NOTICE OF VIOLATION - DELAVEAGA GOLF COURSE, SANTA CRUZ, SANTA CRUZ COUNTY; WDID#344C330064

Attachment 1

Inspection Photos, De LaVeaga Golf Course, Santa Cruz
January 12, 2005

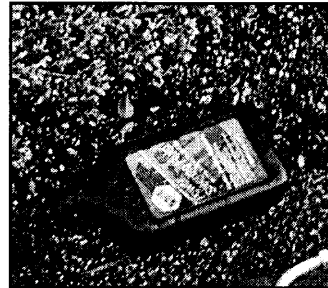
Above and Right: Containers and battery exposed to rain and runoff in construction trailer area. These items should be in secondary containment.

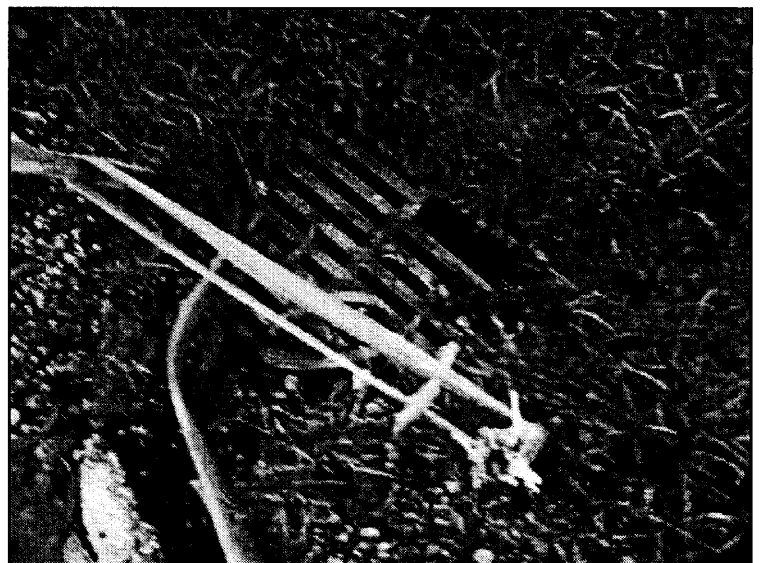
Below and Below Right: Unprotected storm drain inlets.

Above and Right: Greens Complex 18 drainage inlet protection added since last inspection. However there is still significant erosion on slopes (above) and a hole in the filter fabric (right).

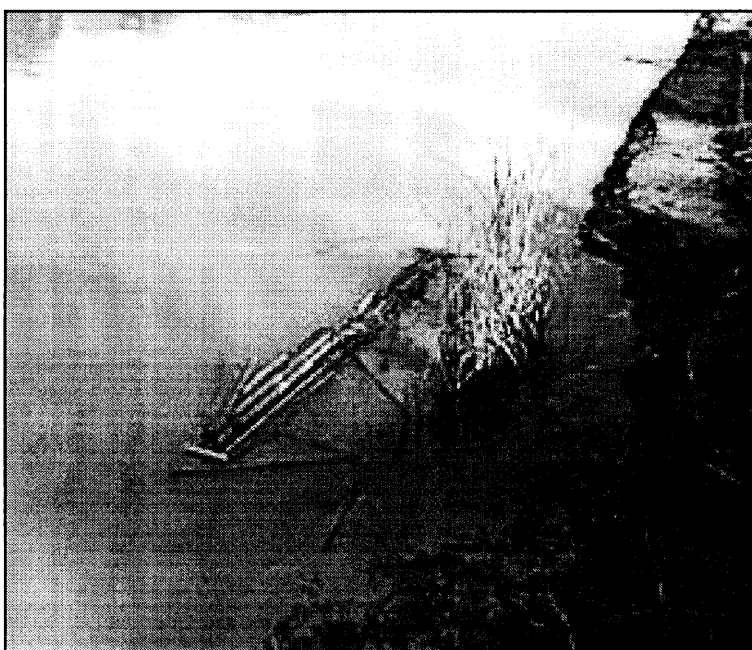
Left: Fiber rolls at Greens Complex 18 not properly staked. Improperly installed fiber rolls are not effective in filtering runoff or slowing it down.

Left and Above: Dewatering (of planter area of clubhouse parking lot) was occurring when staff arrived at the site. Staff is concerned about site dewatering procedures, as person dewatering did not employ any dewatering best management practices, and did not monitor the discharge point before leaving the area. However, when staff observed the discharge point, it appeared water had not yet bypassed sandbags at the parking lot low point.

Left: Pond near Greens Complex 18 discharges to canyons without treatment.

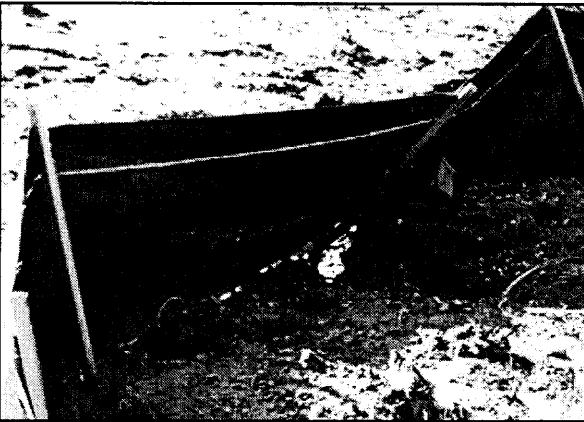
Below: Some construction areas drain to pond. Photo shows muddy water in pond and accumulated sediment below drainage pipe.

This Page: Onsite silt fences improperly installed. Silt fences are not trenched in at the bottom to prevent runoff from flowing under fences.

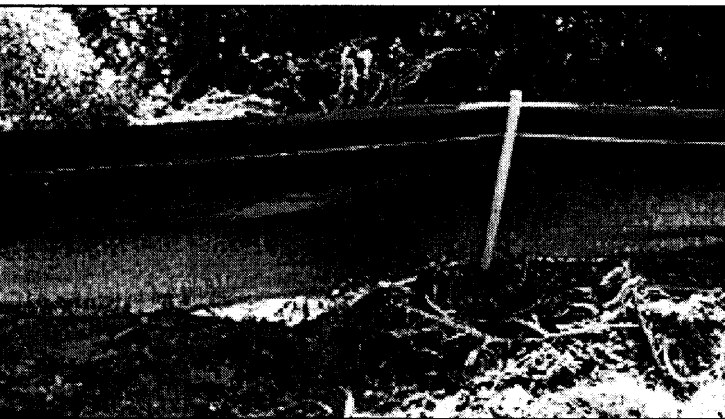
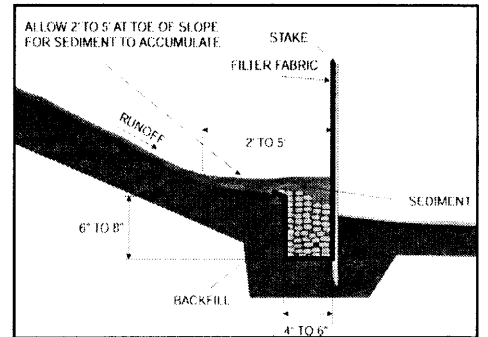
Above and Below: Sediment traveled under silt fences to canyons.

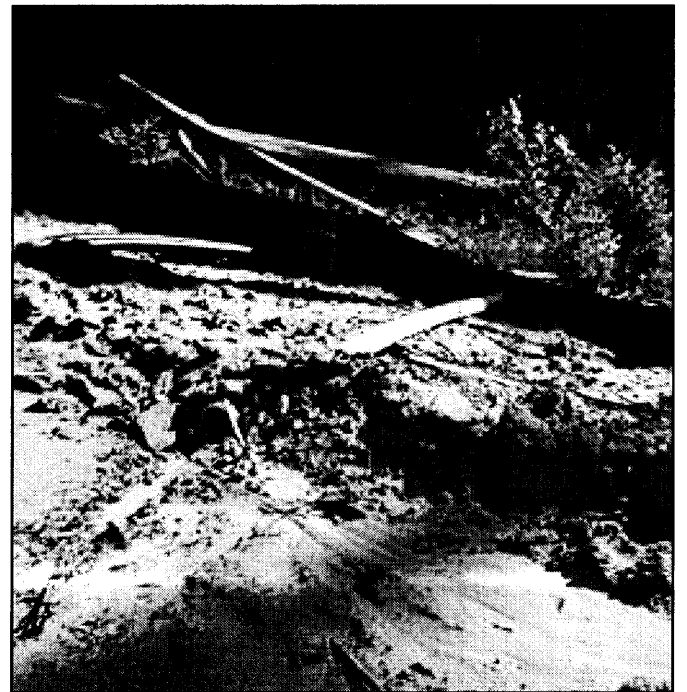
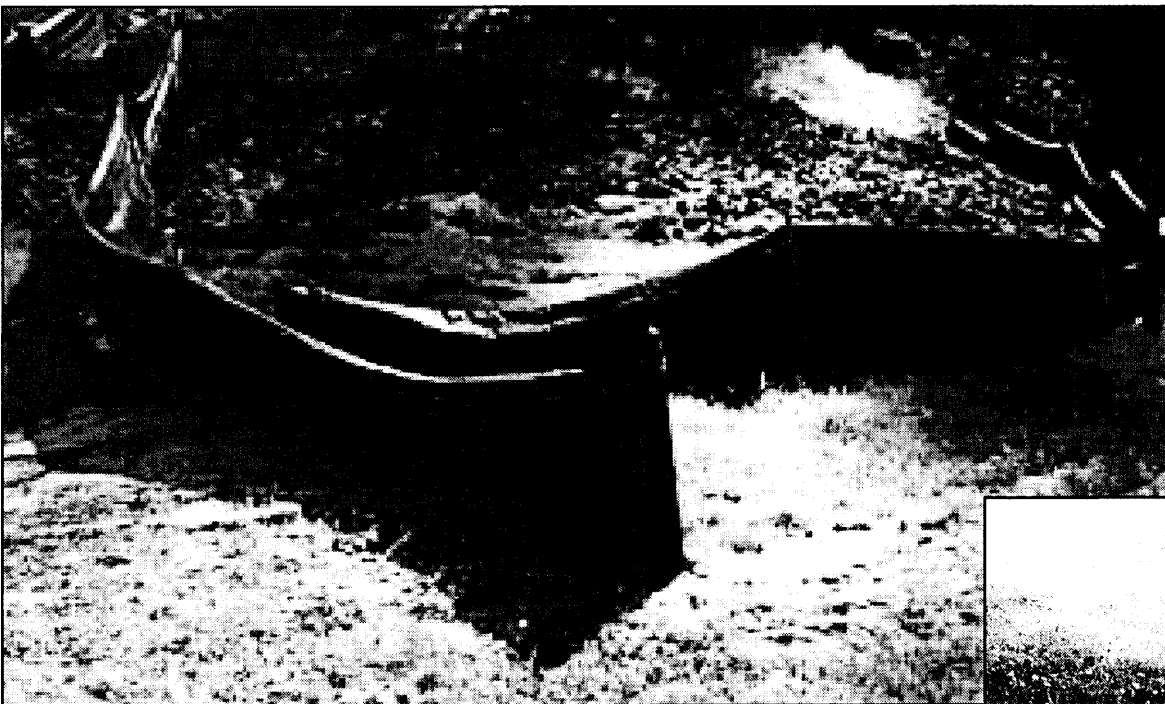
This Page: Silt fences in need of maintenance and/or replacement in various areas of site.

This Page: Pipes through and under silt fences in various locations on site. Such a design does not filter the runoff flowing through pipes, and results in sediment discharge.

Top Left: Sediment-covered pipe going under/through silt fence in Greens Complex 5.

Top Right: pipe on other side of fence. Sediment in grass is evidence of muddy water discharge from pipe.

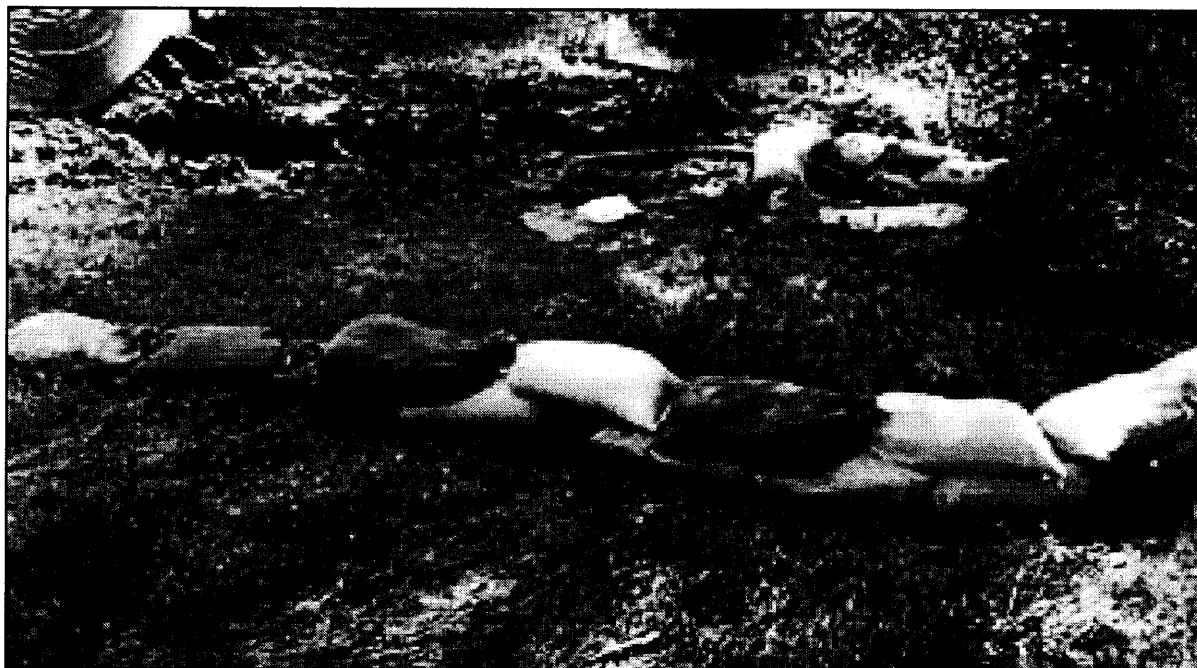
Above and Right: Silt fence and sediment deposited behind and around edge of silt fence at Greens Complex 5. Sediment and flattened grass show path of sediment-laden water around silt fence.

Above: Greens Complex 5. Pipes convey runoff between sandbags.

Left: Greens Complex 5 discharge point. Pipe and sandbags at edge of golf course, adjacent to canyon. No sediment controls beyond this point.

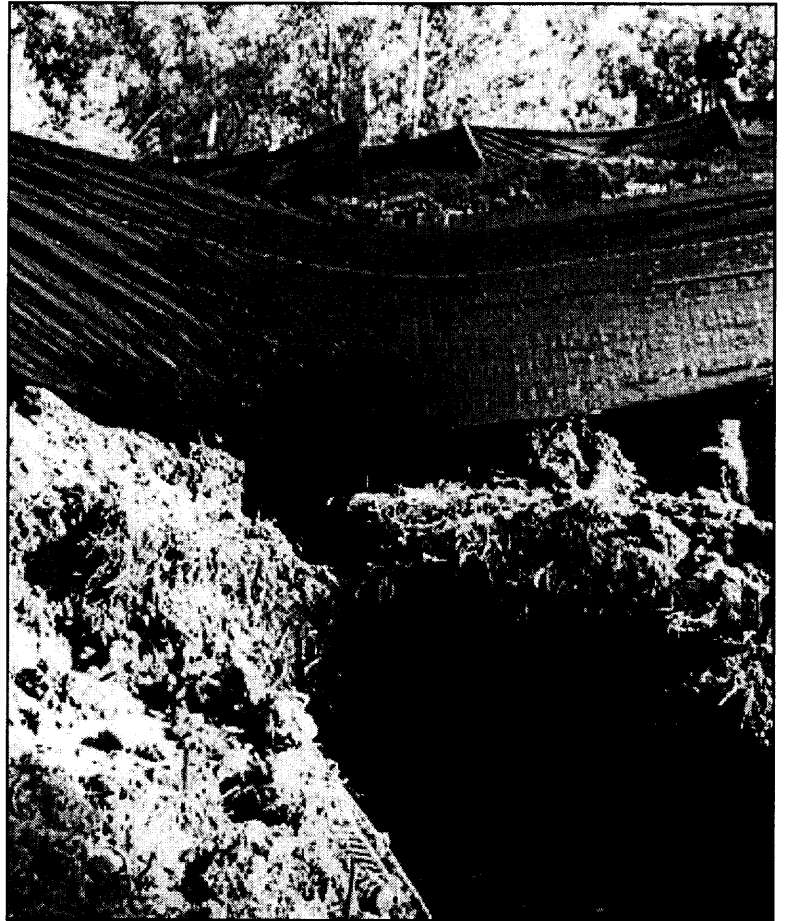
Right and Below: Erosion and sediment deposits in canyon directly below sandbags at Greens Complex 5 discharge point.

Above: Greens Complex 5. Sediment on both sides of silt fences (third silt fence to right is not visible in above photo).

Right: Erosion/trench below third silt fence.

Below: Third silt fence (left side of photo) and erosion/trench with pipe into Greens Complex 5 discharge point.
